WALDEN PRESERVE 2

Filing No. 4

Grading & Erosion Control Plans

PCD FILE NO. SF-18-034

SHEET: **C1**

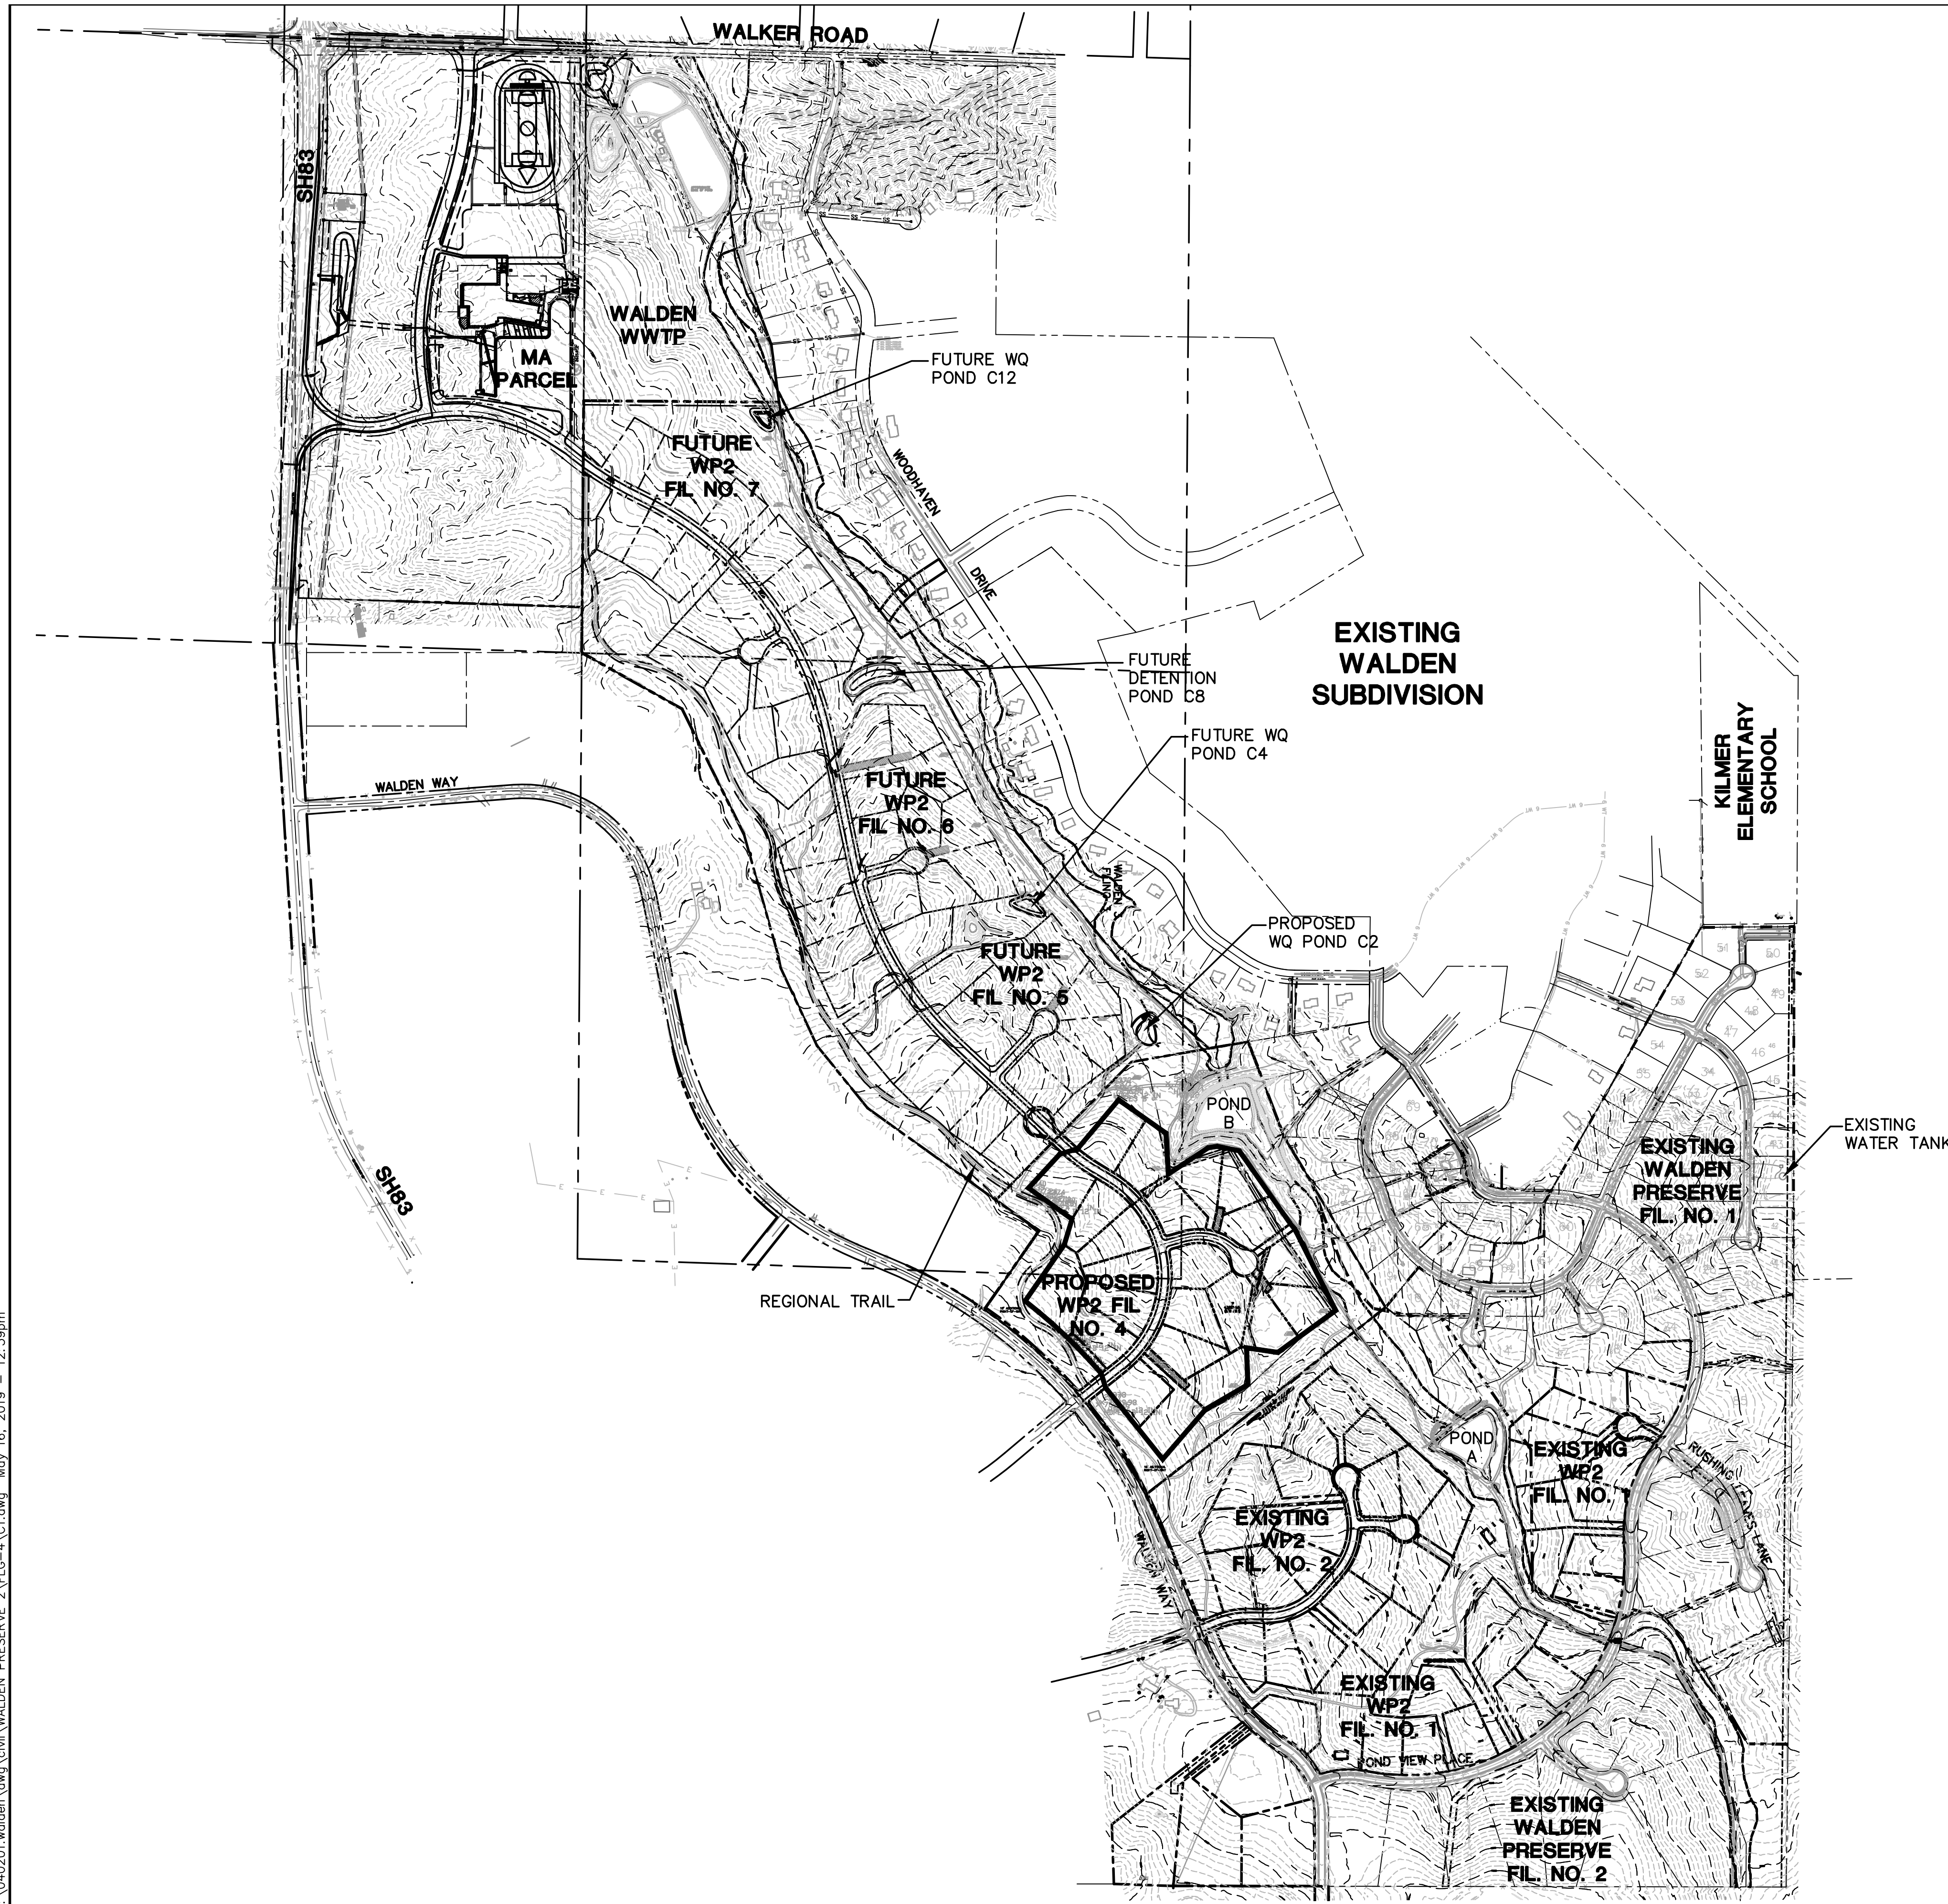
identify as temp sediment pond during construction and provide details.
